DOCUMENTATION TRANSMITTAL

Documentation Description: Nonconformance Report - C-02834-V

NONCONFORMANCE REPORT

Welded Connections of Structural Supports

DETAIL 2

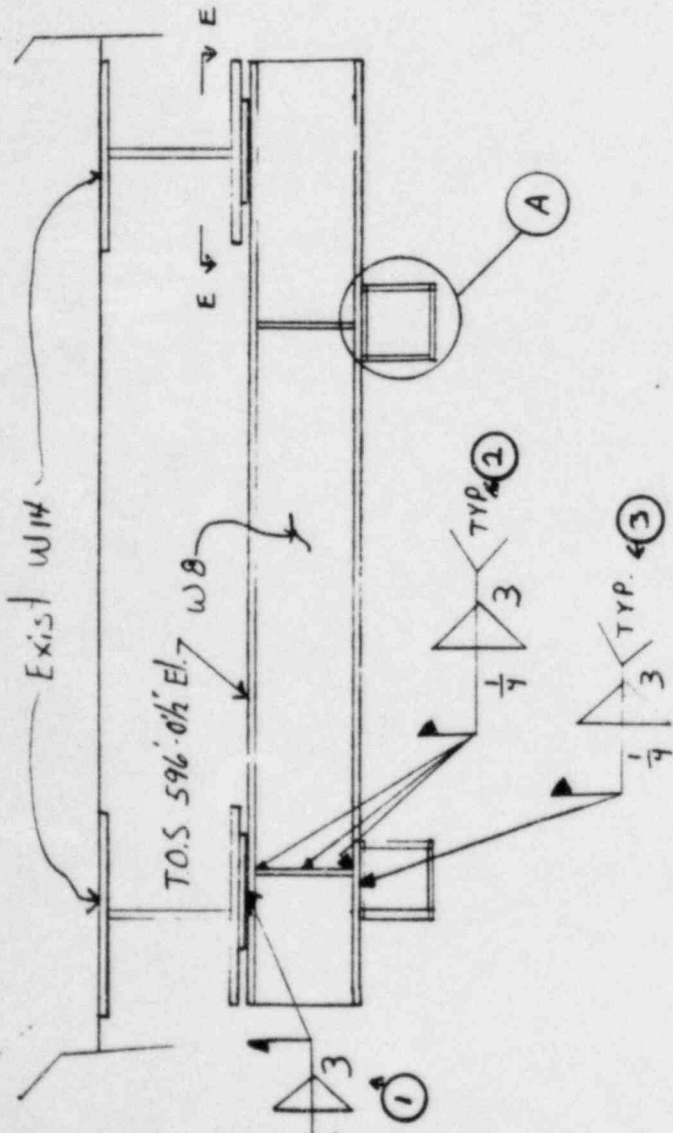
Ref. Dwg C-855
QC Roll Out

EXIST. 1/2" R
TOP & BOT FLG

1/4" x 7/8" STIFF R EA SIDE

Detail A
 (Ref. Dwg. C862)

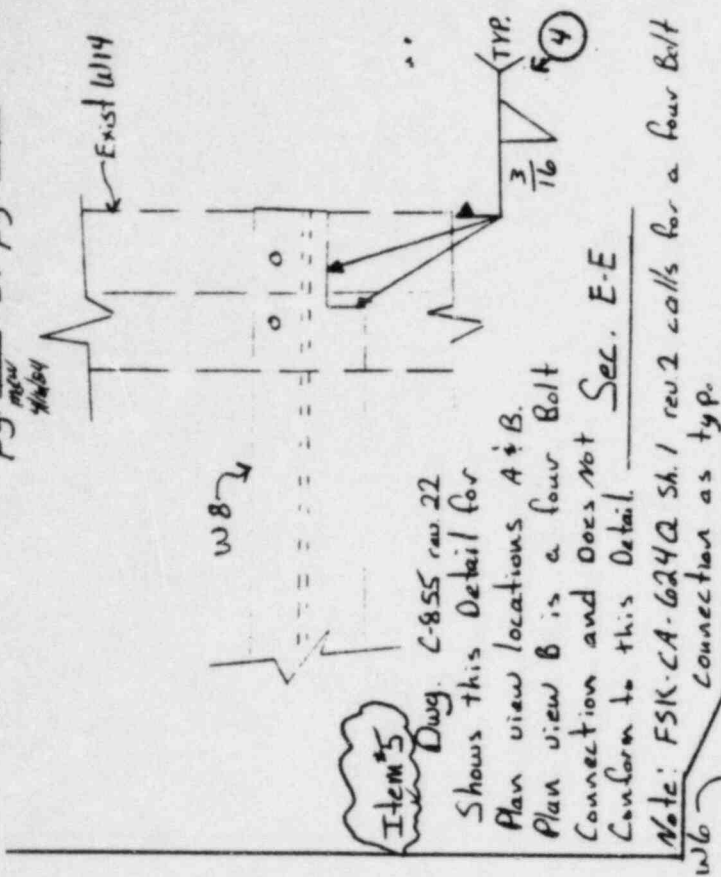
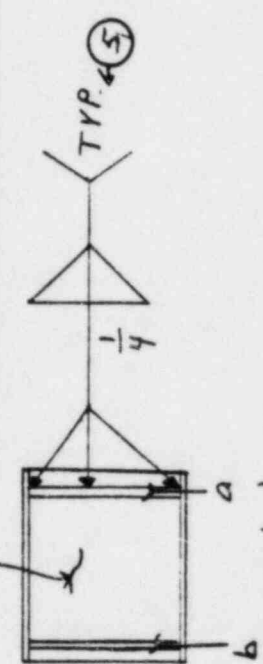
Item 5
 Dwg. C-855 rev 22
 Shows this Detail for
 Plan view locations A & B.
 Plan view B is a four Bolt
 Connection and Does Not Sec. E-E
 Conform to this Detail.
 Note: FSK-CA-624Q Sh. 1 rev 2 calls for a four Bolt
 Connection as typ.

Weld A2NS

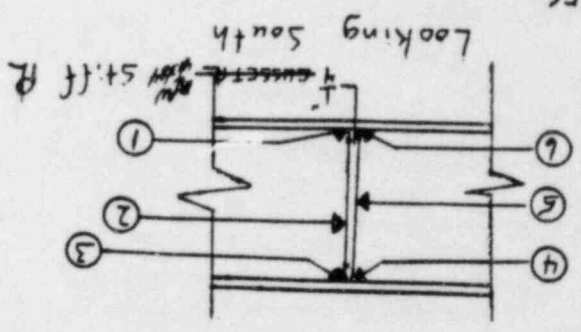
Notes: Undersize = 1 leg $\frac{3}{16}$ "
Insufficient Throat = $< \frac{1}{4} \geq \frac{3}{16}$ " *
* Fillet Gage Size
* Gouges in weld metal apparently caused by grinding.

1) Gouge in weld metal (G.W.M) *
 $2 \frac{1}{4}$ " length $\frac{3}{32}$ to $\frac{1}{8}$ " Deep

2) $5 \frac{7}{8}$ " length
G.W.M. $4 \frac{3}{8}$ " length $\frac{3}{32}$ " Deep

1) Insufficient Throat $\frac{1}{2}$ " \approx

2) $5 \frac{7}{8}$ " length
Insufficient Throat & Undersize 100%

3) Insufficient Throat 50% \approx
Undersize 100%

4) Undersize 100%

5) Undersize & Insufficient Throat 100%

6) Undersize 100%
Insufficient Throat 50% \approx

1) Undersize 25% \approx Insufficient Throat 80% \approx

2) Undersize & Insufficient Throat 100%

Weld A2FS

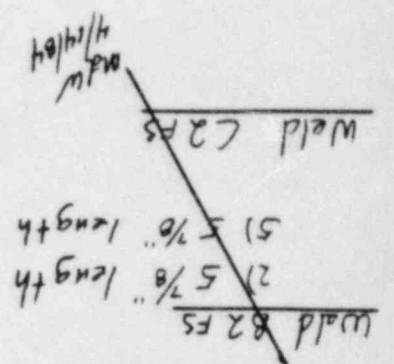
- 1) Under size & Insufficient Throat 90% \approx
- 2) 5/2" in length
- Under size 90% \approx Insufficient Throat 1" \approx
- 3) Under size 60% \approx Insufficient Throat 1" \approx
- 4) Under size 25% \approx Insufficient Throat $\frac{1}{2}$ " \approx
- 5) Under size 90% \approx Insufficient Throat 75% \approx
- Length 5/2"
- 6) Under size & Insufficient Throat 50% \approx

Weld C2FS

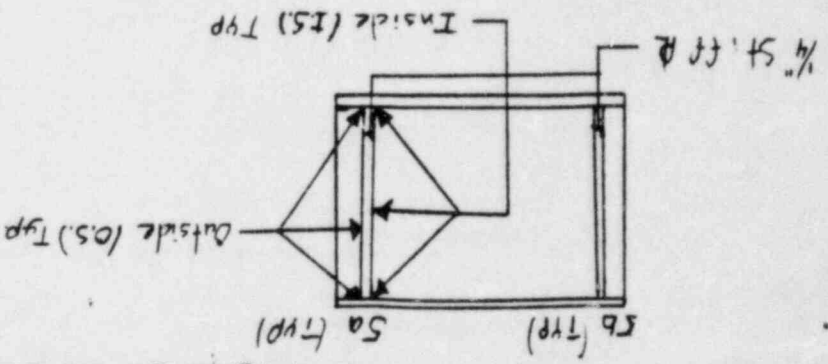
- 1) Under size & Insufficient Throat 100% \approx
- 2) 5/8" length, Under size 100% \approx
- 3) Crater Not filled to full cross section of weld
- 4) Length 5/8" Insufficient Throat & Under size 25% \approx
- 5) Insufficient Throat & Under size 90% \approx
- 6) Base metal seam runs up to the toe of each weld.

pg 28 of pg 9
 Item # 5
 Doug L-855 re 22 calls for these
 stiff fls to be on the South
 side of the W6 x 15.85
 The opposite exists in the field.

Weld A5a
 O.S. Undersize & Insufficient Throat 100%
 I.S. Undersize 80% = Insufficient Throat 25%
 Item # 1

Weld A5b
 O.S. Undersize & Insufficient Throat 100%
 I.S. Undersize 100% Insufficient Throat 10%
 Item # 1

Weld D5a
 O.S. Undersize 25% = Insufficient Throat 25%
 I.S. Undersize & Insufficient Throat 40%
 Lack of Fusion & Slag Included 1/2" length
 Bottom Corner not web & stiff fl
 Item # 1 & 3

Weld D5b
 O.S. Undersize 100% Insufficient Throat 95%
 I.S. Undersize + Insufficient Throat 50%
 Item # 1

Weld B5a
 O.S. Undersize 100% Insufficient Throat 90%
 I.S. Undersize 100% Insufficient Throat 50%
 Item # 1

Weld B5b
 O.S. Undersize & Insufficient Throat 100%
 I.S. Undersize 80%
 Item # 1

Weld C5a
 O.S. Undersize & Insufficient Throat 100%
 I.S. Undersize 100% Insufficient Throat 10%
 Item # 1

Weld C5b
 O.S. Undersize 90%
 I.S. Undersize & Insufficient Throat 80%
 Item # 1
